SERVICE BULLETIN

APPLICABILITY: 2008-2010MY 5-Door Impreza **NUMBER:** 07-71-12
SUBJECT: Revised Packing Material for the License Plate Lamp **DATE:** 12/03/12

Cross-Sectional View of License Lamp and Rear Gate

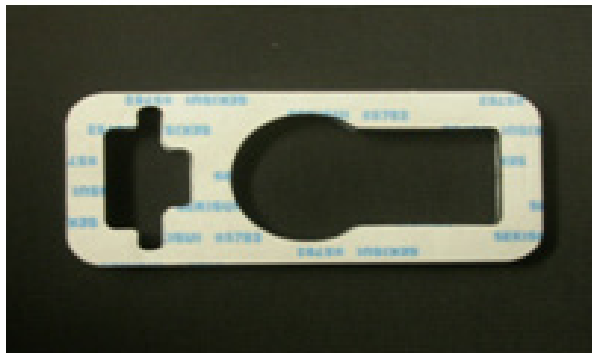
The packing (gasket) material for the license plate lamp has been revised to improve the sealing performance to the rear gate panel. The new material is thicker to provide a better seal and help prevent corrosion which may develop as a result of contact between edges of the lamp assembly and the paint finish.

- Remove the license lamp assembly from the rear gate following the procedure in the applicable Service Manual.
- Using a plastic trim tool, remove all of the old packing material from the license lamp assembly. Clean off all residual adhesive and dirt using a plastic safe adhesive remover like “Goo Gone” or similar product.
